SAN FRANCISCO PLANNING DEPARTMENT

Discretionary Review Abbreviated Analysis HEARING DATE: JANUARY 9, 2020

Date: December 27, 2019
Case No.: **2018-003023DRP-02**
Project Address: **2727 Vallejo Street**
Permit Application: 2018.0214.1303
Zoning: RH-1 (D) [Residential House, One-Family- Detached]
 40-X Height and Bulk District
Block/Lot: 0959/022
Project Sponsor: Lewis Butler
 Butler Armsden Architects
 1420 Sutter Street
 San Francisco, CA 94109
Staff Contact: David Winslow – (415) 575-9159
David.Winslow@sfgov.org
Recommendation: **Take DR and Approve with Modification**

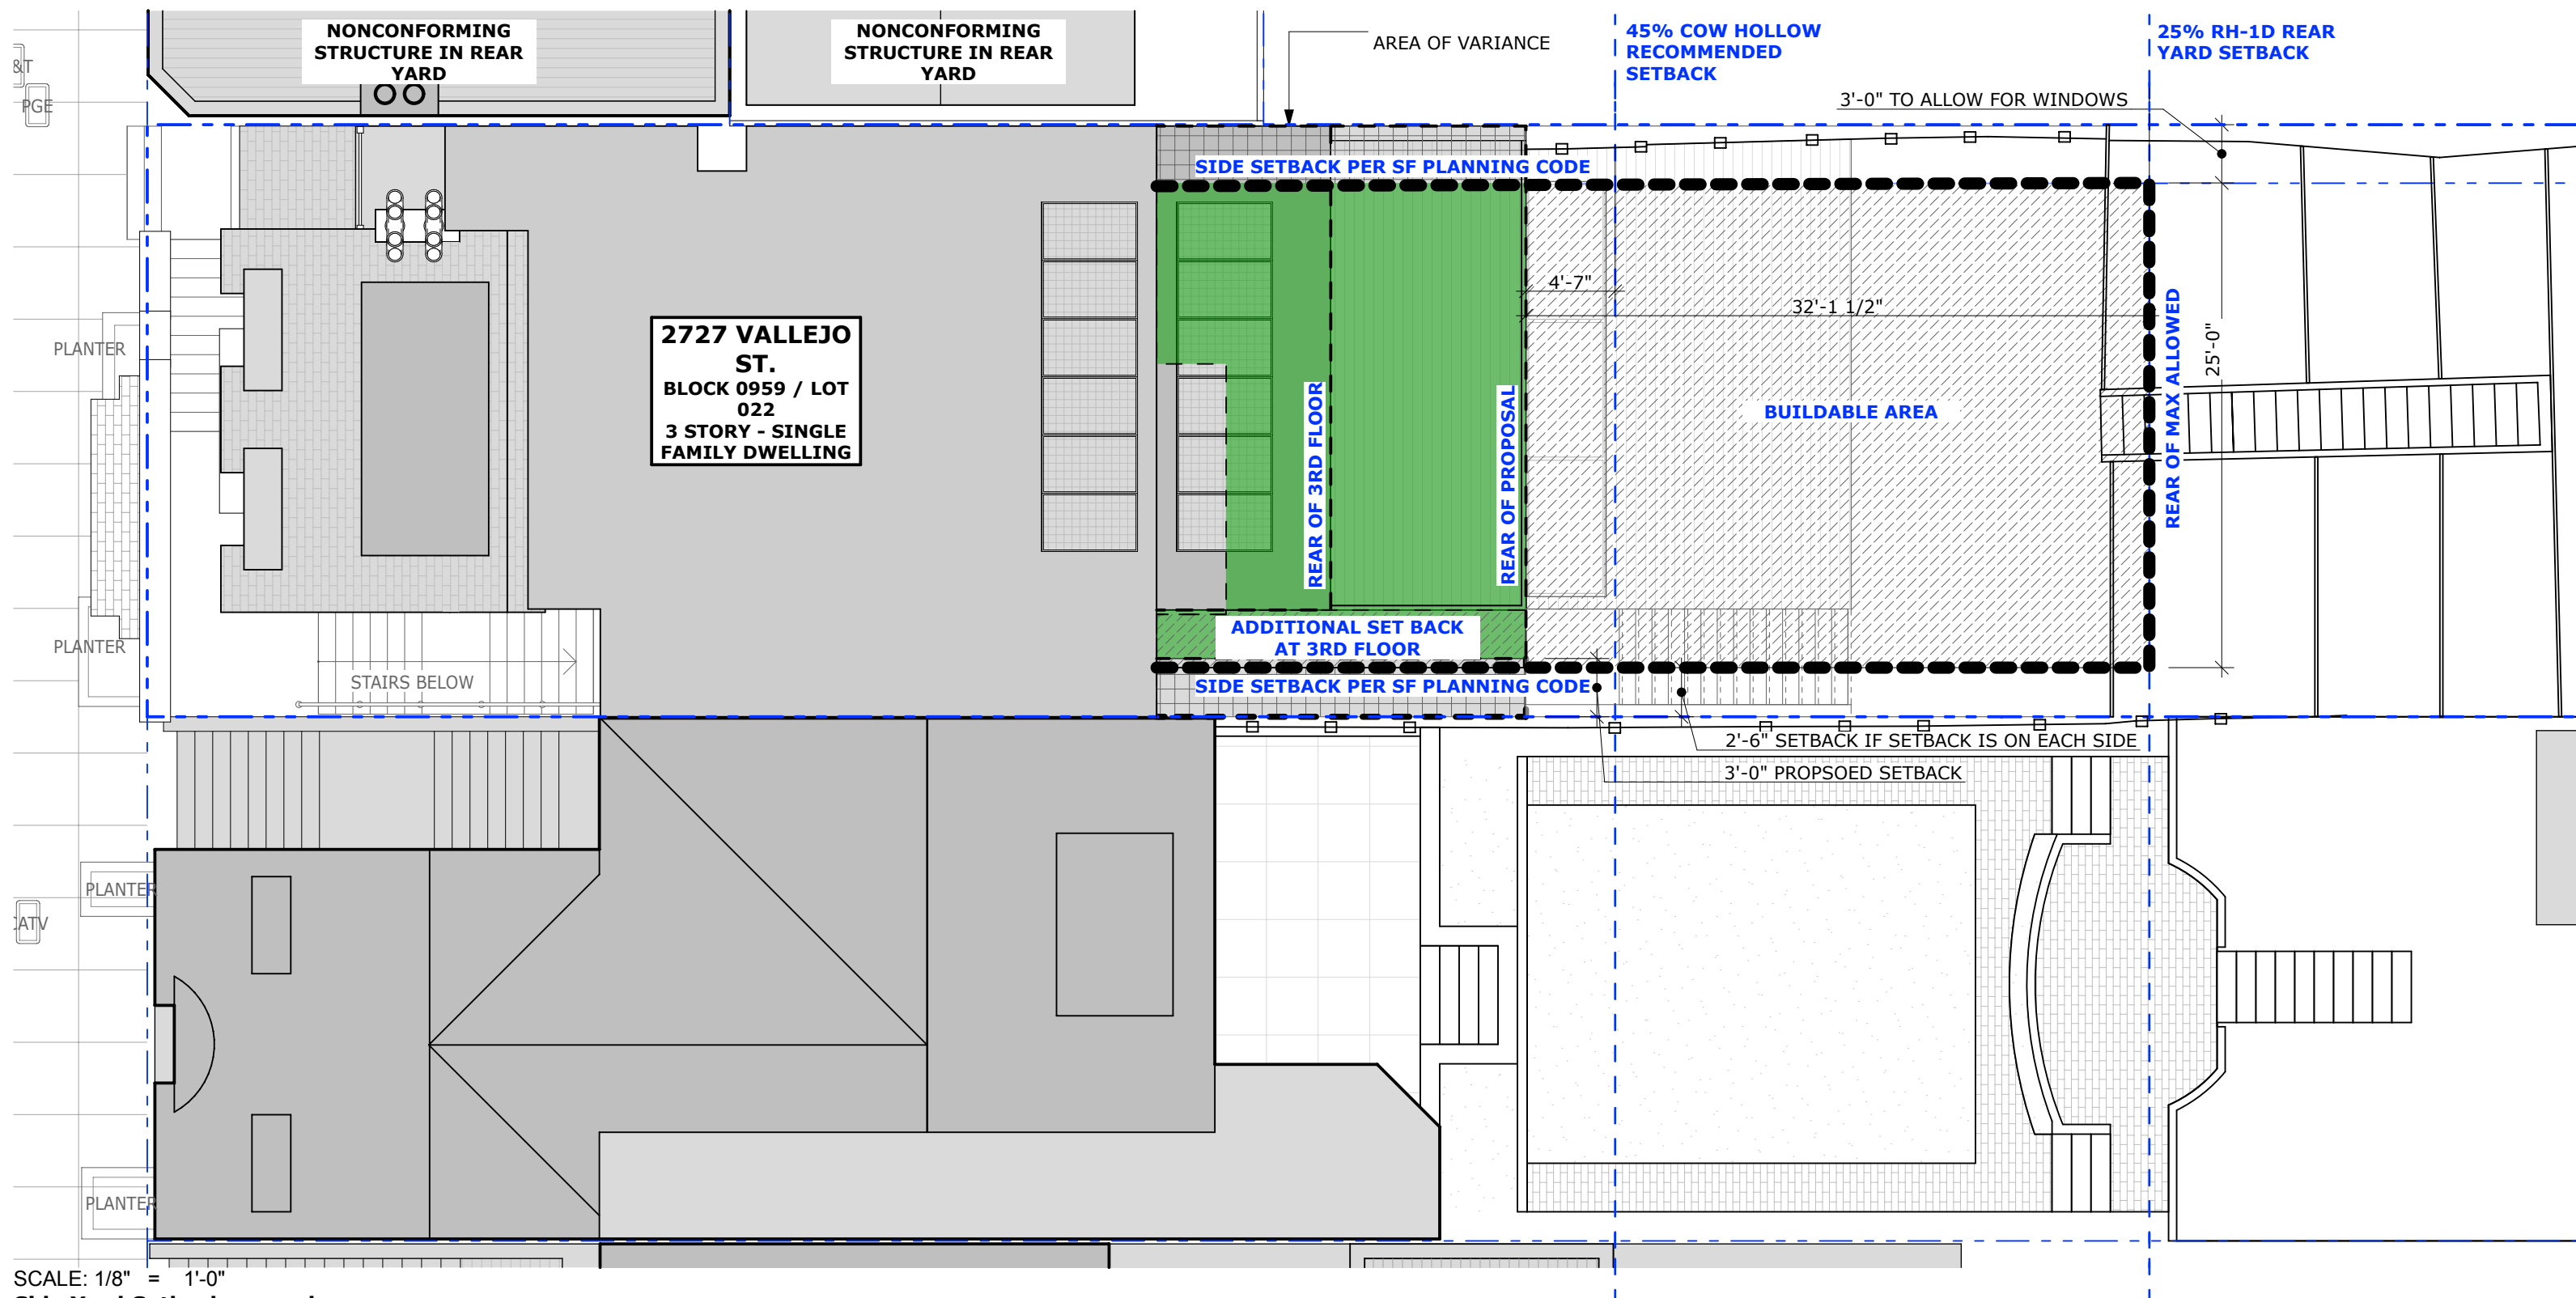
•PROPOSED SIDE YARD SETBACK IS 3' ON THE SECOND FLOOR AND 5'-6" ON THE THIRD FLOOR

•COW HOLLOW RECOMMENDED REAR WALL IS 45% LOT DEPTH, PROPOSED IS 4'-7" LESS

•SF PLANNING REAR YARD REQUIREMENT IS 25%, PROPOSED IS 32'-1 1/2" LESS
